**Subject: Former GE Farrell Road, NYSDEC Site No. 734055
Response to Submittal of Subsurface Investigation Work Plan
in the Vicinity of Building #2**

**SUBSURFACE INVESTIGATION WORK PLAN
IN THE VICINITY OF BUILDING #2**

NYSDEC Site Number: 734055

**May 2019
(Revised June 2019)**

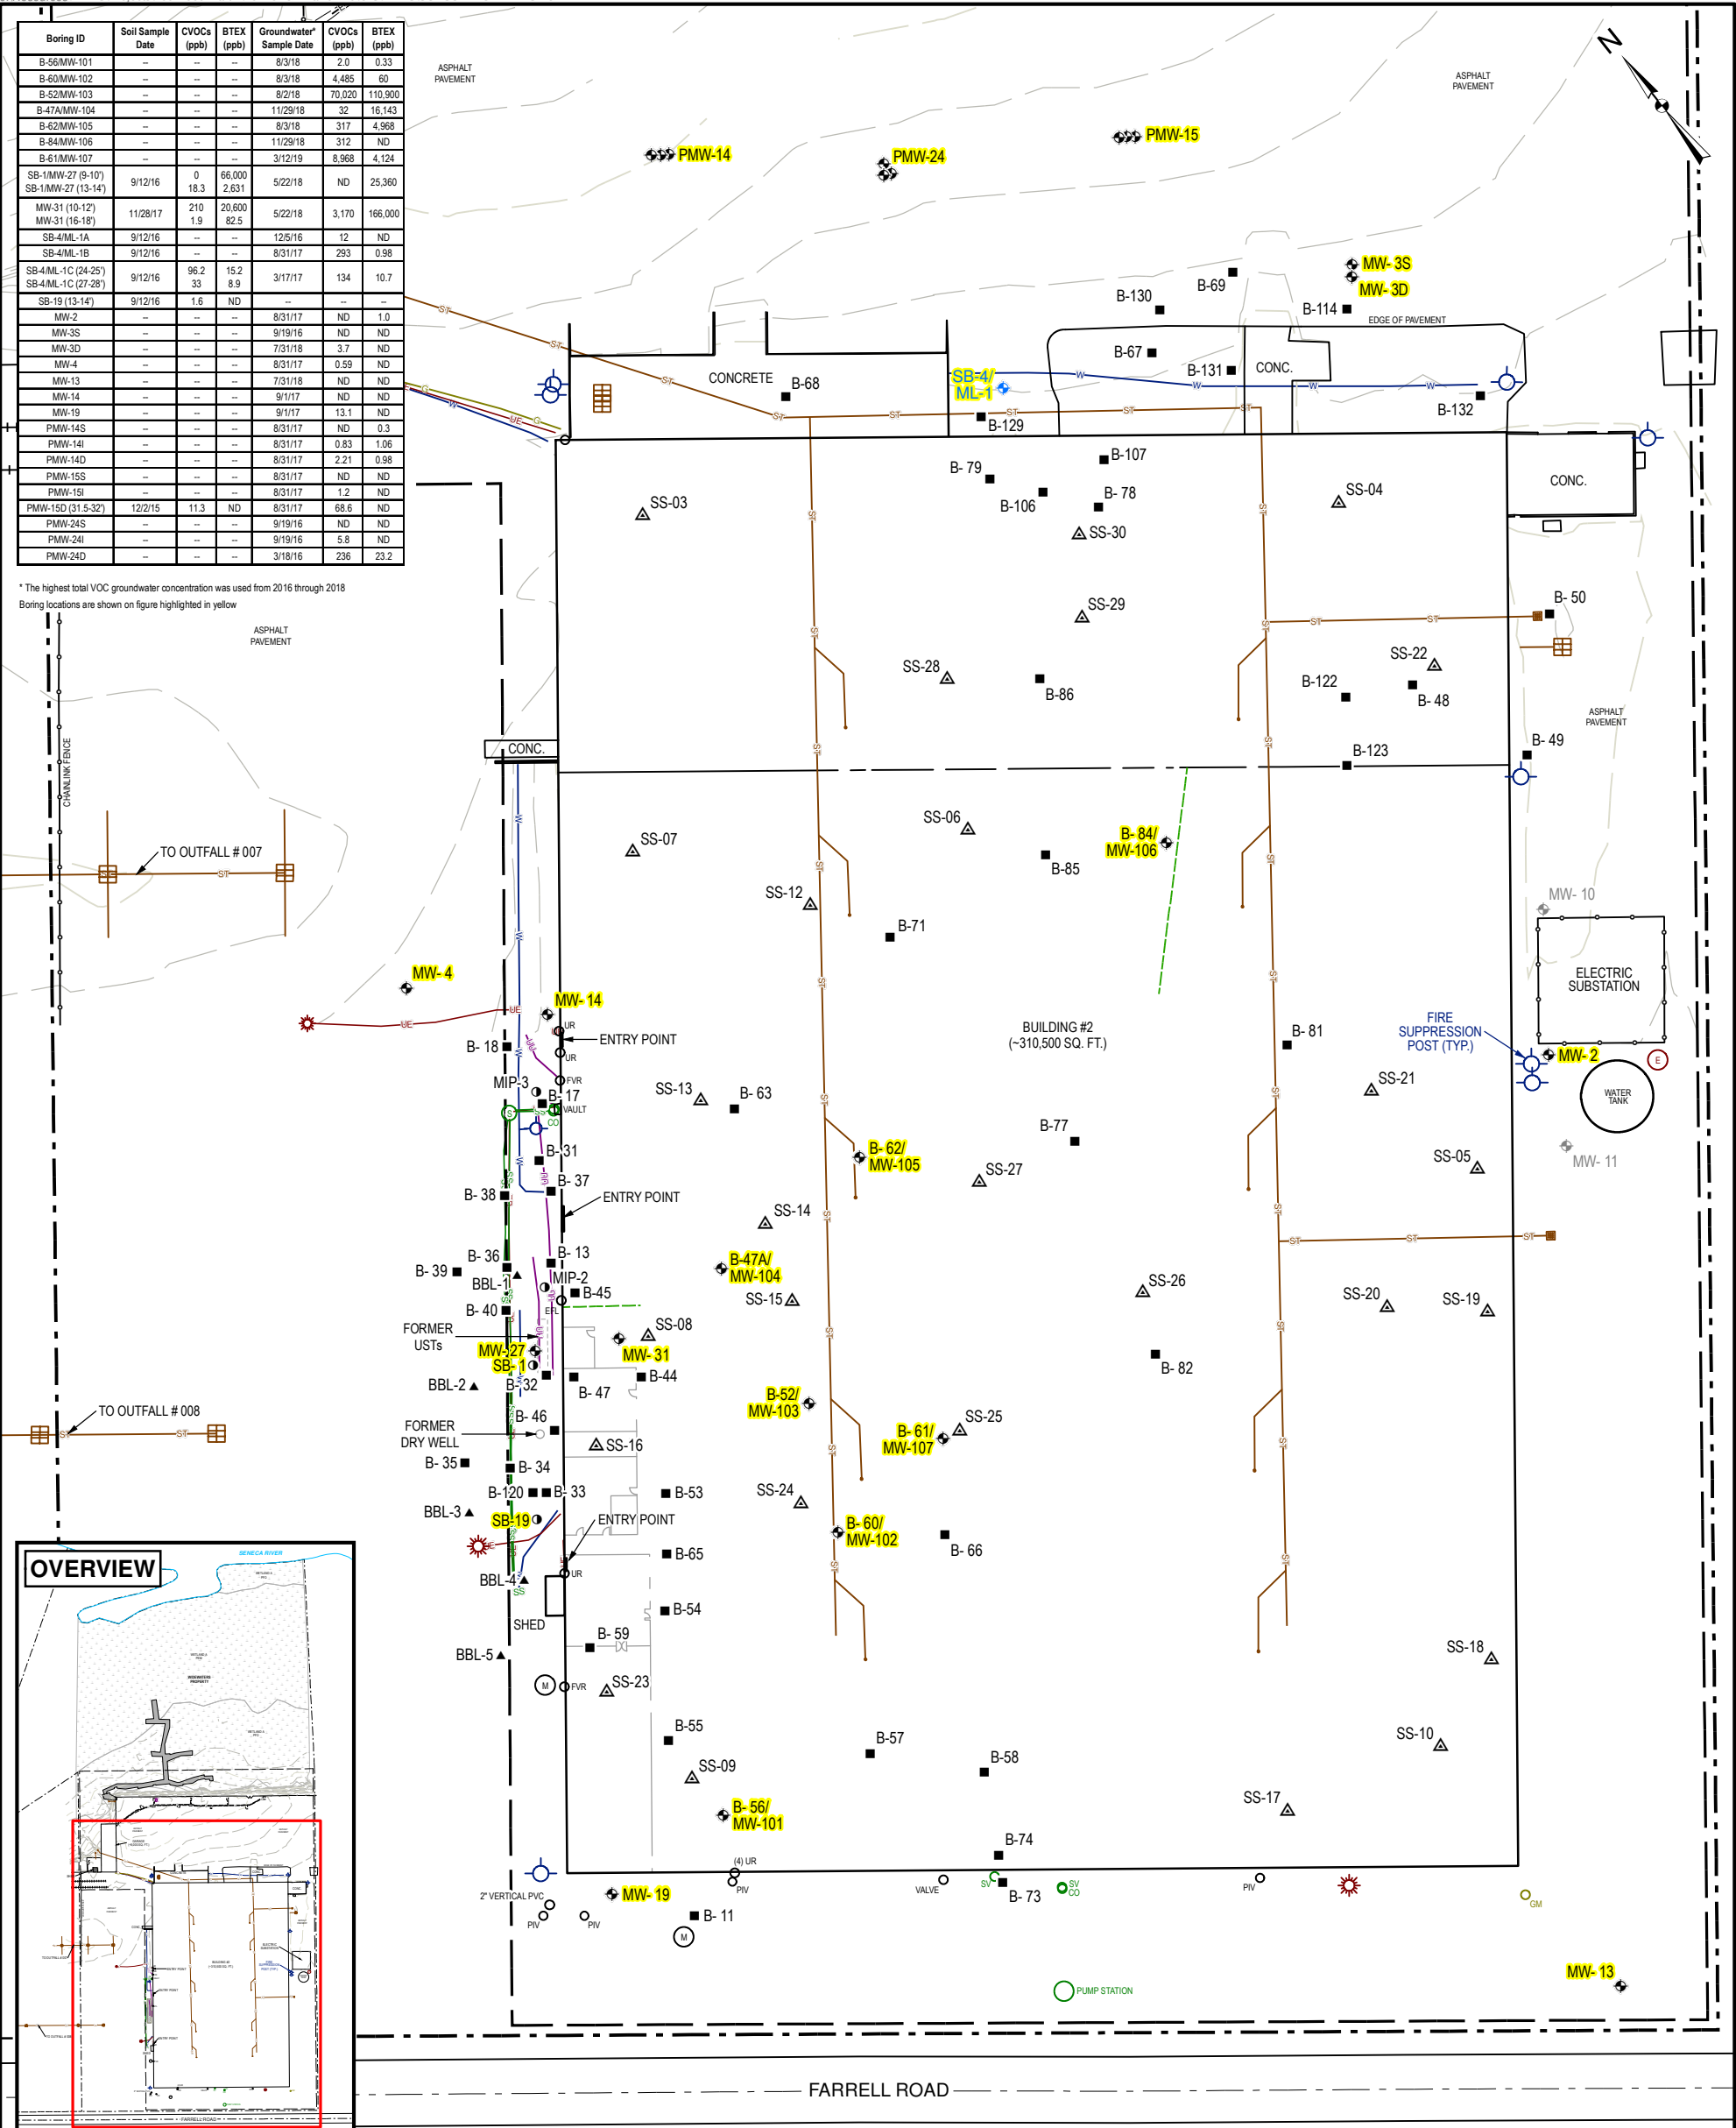
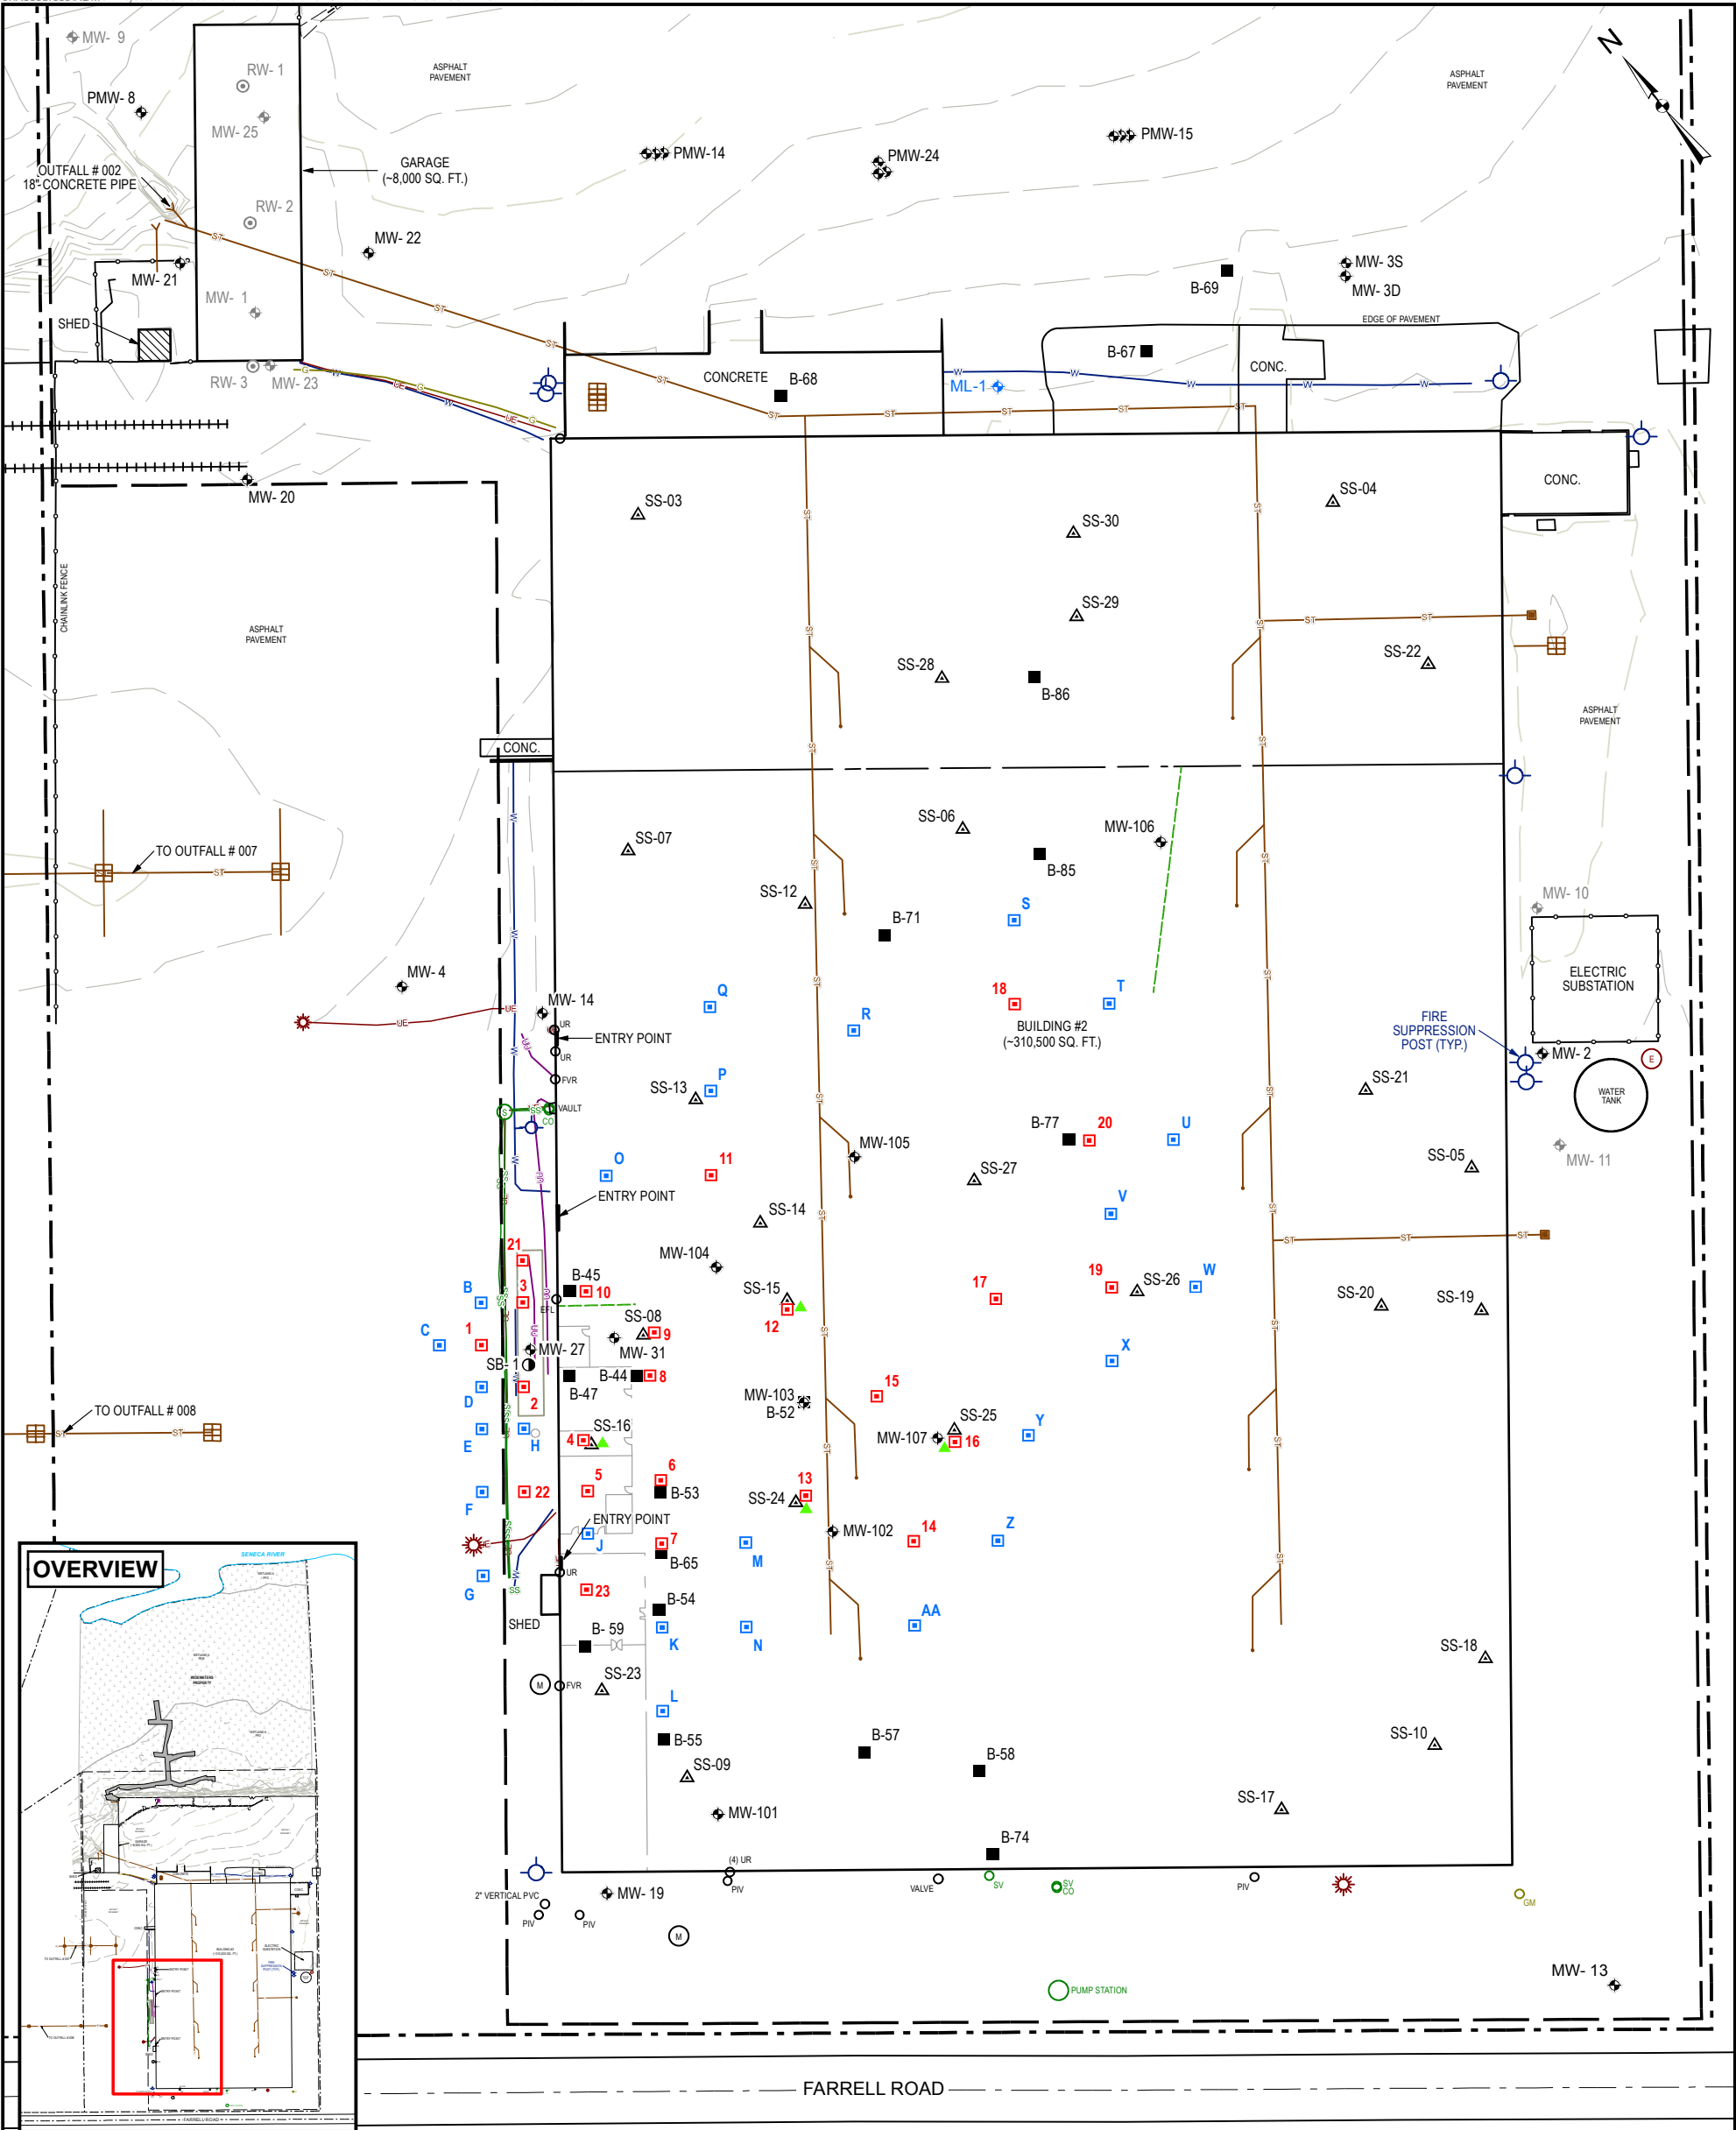
16. *Figure 6 – A boring must be installed at locations A and I, and contingent borings must be added north of A and south of I. A boring must be installed inside the building immediately inside of the shed (between locations B-59 and J), as close to the building wall as possible.*

This comment is acknowledged and Figure 6 has been revised to reflect the adjustment.
